LANDSCAPE ARCHITECTURE PEER REVIEW

APPLICATION: RM240167- GODLEY PEAKS STATION HOMESTEAD

3 March 2026

Landscape Assessment Peer Review

Figure 2: Planting plan with selection of native species.

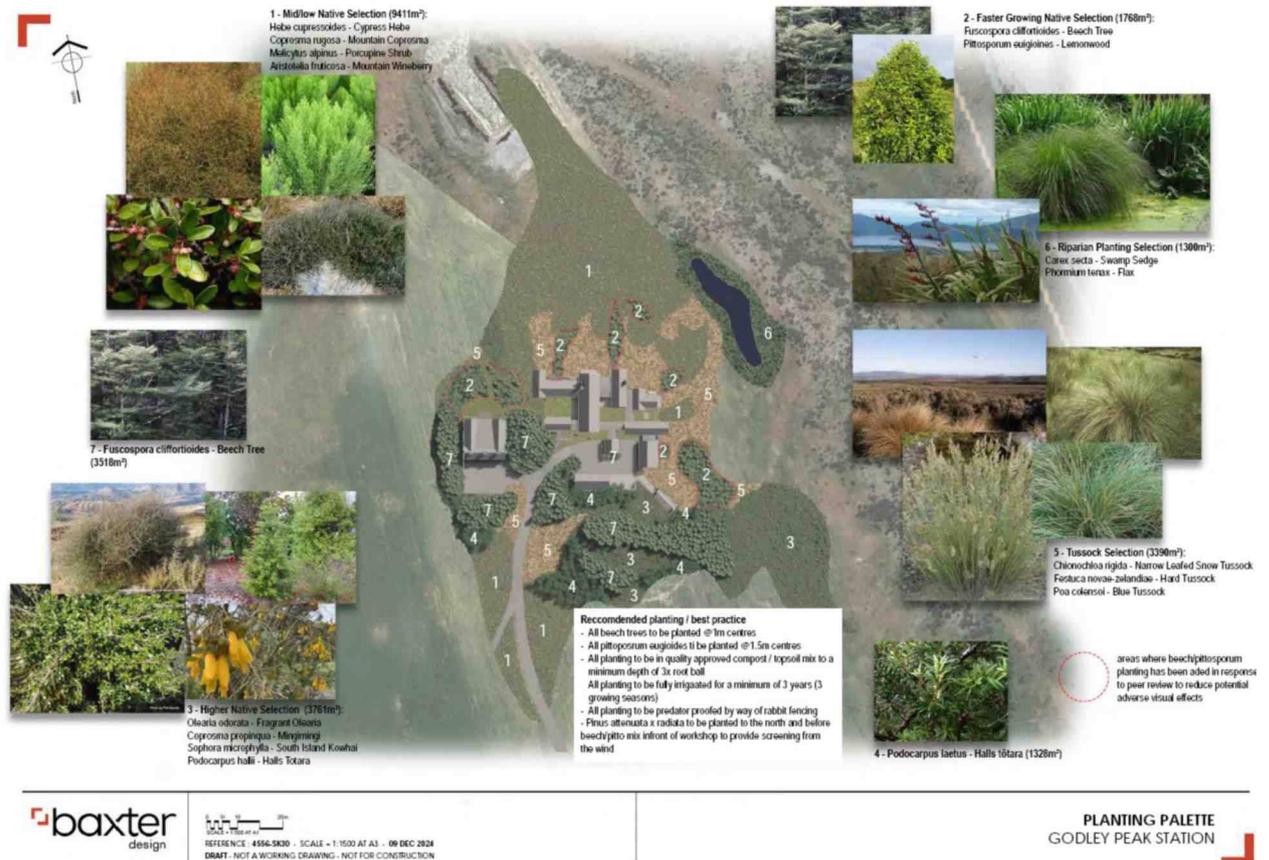
- 5.13 Based on landscape and ecology considerations Mr Hooson (para 3.50) and I, therefore, consider that in this context, the use of faster growing indigenous trees such as *Pittosporum eugenioides* is acceptable to achieve the desired landscape mitigation.

We recommend manatu / lowland ribbonwood (*Plagianthus regius*) as another fast-growing, wind and frost tolerant indigenous tree species that could be considered as an alternative or an addition.

Figure 3: Baxter Design Response Temporary Shelter Planting Plan.

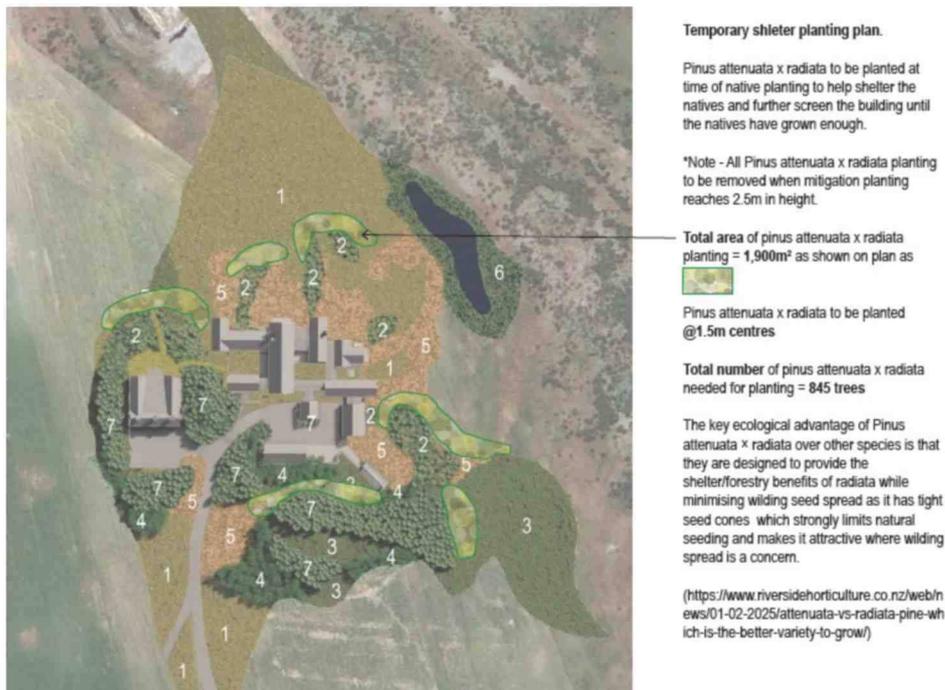
5.14 Mr Hooson and I have assessed the proposed planting of exotic species (*Pinus attenuata*) on the northern side of the proposed native species as shown on the recently prepared cross-sections (Baxter, Jan 2026, p.7). We consider (see also Hooson, para 3.51) that this planting would provide a wind-break and protection for the native planting during the establishment period and support this approach, including the subsequent removal of conifers once the native tree planting reaches a height of 2.5m. We assessed the proposed location of this temporary planting on the amended masterplan, and consider the location to be appropriate to shelter the native planting from the wind predominantly from a northerly direction along the lake (as shown on Baxter Design Response Temporary Shelter Planting Plan, see Figure 3 below).

- 8.6 The design statement (Baxter Design) outlines the proposed planting as follows: *Three broad mixes of planting including (a) tussock selection, (b) Mid – low Native Selection (1-2m height at maturity) and (c) Higher Native Selection, including taller shrub planting at 2-2.5m and tree planting, being Kowhai and Mountain Beech. The total area of proposed planting is substantial being approximately 22,100m² in size.* In general, I am in support of the proposed planting in terms of species and location. However, the advice in terms of species suitability provided by the ecology peer review should be taken into account.
- 8.7 The proposed planting of *Pinus attenuata* as shown on the masterplan is recommended in the proposed location (Figure 3) to provide an effective temporary wind-break for the native planting.

Figure 5: Potential location for implement shed to move it further out of the visual catchment of the lake in a lower-lying location.

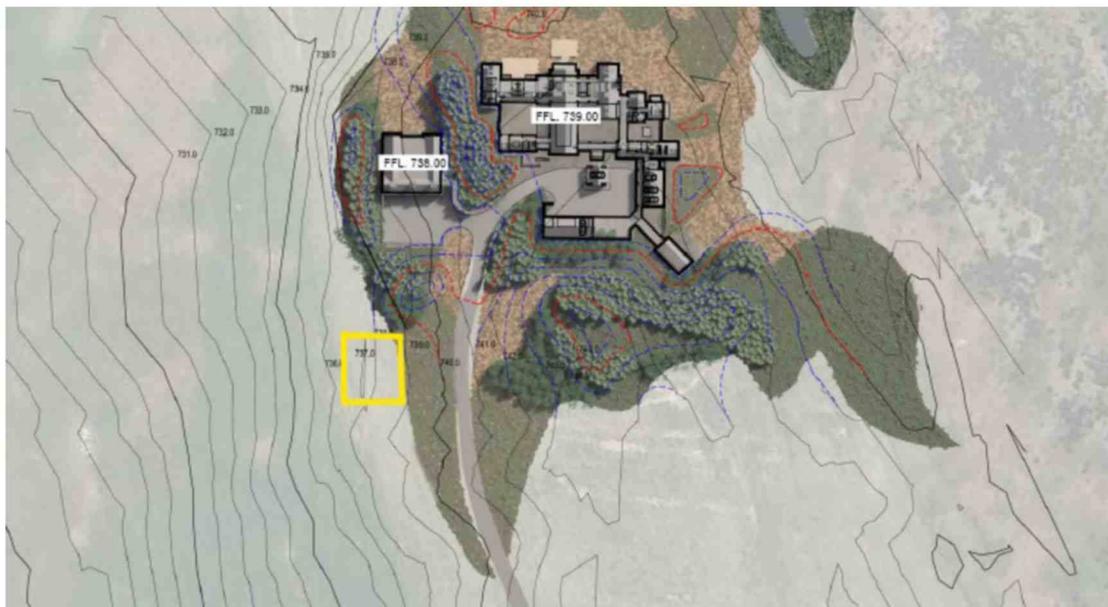
- 8.3 I consider that lowering the RL of the building platform for the implement shed will reduce its visual effect when viewed from the north-eastern aspect on the lake, in combination with the proposed planting/ mounding. However, I remain of the view that moving the large shed away from the building cluster would further assist in reducing the impact of the large built form to help integrate the proposal into the landscape in this location. There are locations available to the south-west of the proposed location, where the building would be located lower in the terrain and visually contained by the elevated landform to screen it from the lake. Figure 5 below shows a potential location where a lower-lying terrace is available near the access road (based on contour information, not ground-truthed on site). Given that this building will not contain residential use I do not consider that it requires the same outlook as the proposed residential buildings that are maximising the lake views to the north.

Figure 6 Ecological Restoration Planting Reference Plan from FBP with blue area outline for Lakeface Planting.

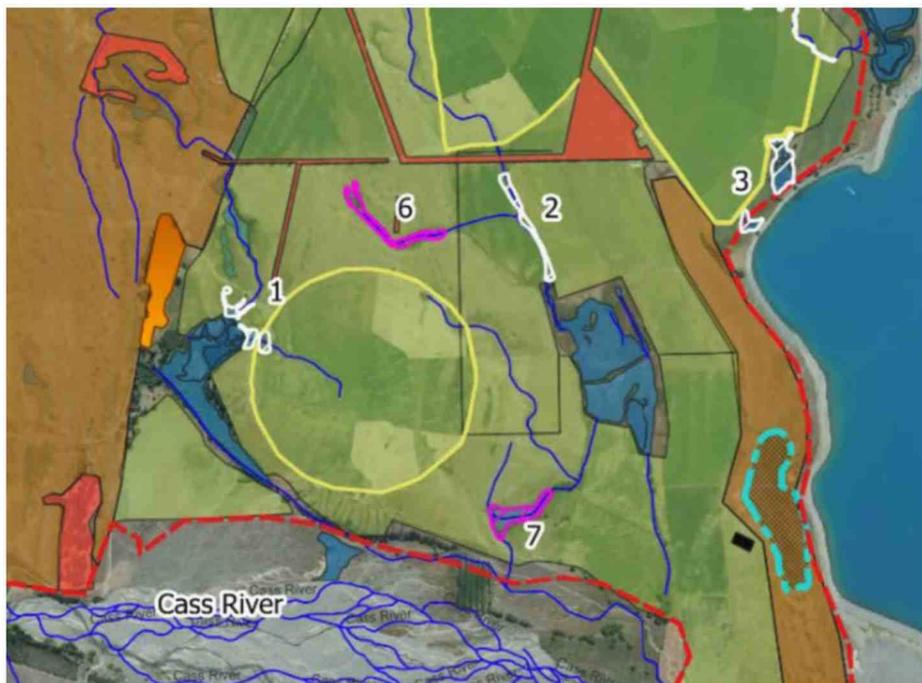
- 8.4 In order to reduce the potential adverse cumulative effects when viewed from this direction, I recommend implementing a building restriction on the high-lying part of the existing Farm Base Area. While built form in the lower part of the area would not be seen together with the proposal, a large building on the upper terrace within the FBA would be visually prominent as confirmed by the V&E assessment.
- 8.5 The lakeside escarpment currently only contains sporadic grey shrubland cover. Figure 6 below shows the Lakeface Planting area (blue outline) and I consider that this planting would provide the wider integration of the proposed masterplan planting with the surrounding lake escarpment landform. As outlined in Section 4.2.3.2 of the Farm

Biodiversity Plan, it is proposed to plant 1000 grey shrub land species at a rate of 200 plants/yr to be completed by 2030 in this area. I consider that this will help to anchor the proposed built form and planting on the upper terrace in this part of the landscape and recommend, therefore, that this planting would be implemented at the same time as the proposed masterplan planting. It would also provide some natural character benefits in the LPA in the vicinity of the dwelling. It is currently unclear where these grey shrubs would be planted, what area they would cover and at what spacing they would be planted. In my view, this planting area should be shown as part of the masterplan and in currently open areas (where no existing grey shrubs are present) a spacing of around 1m in clusters would be appropriate to provide meaningful coverage. I consider that grey shrubland species would be appropriate, but note that Mr Hooson has commented on the proposed selection of species provided in Appendix D of the FBP.
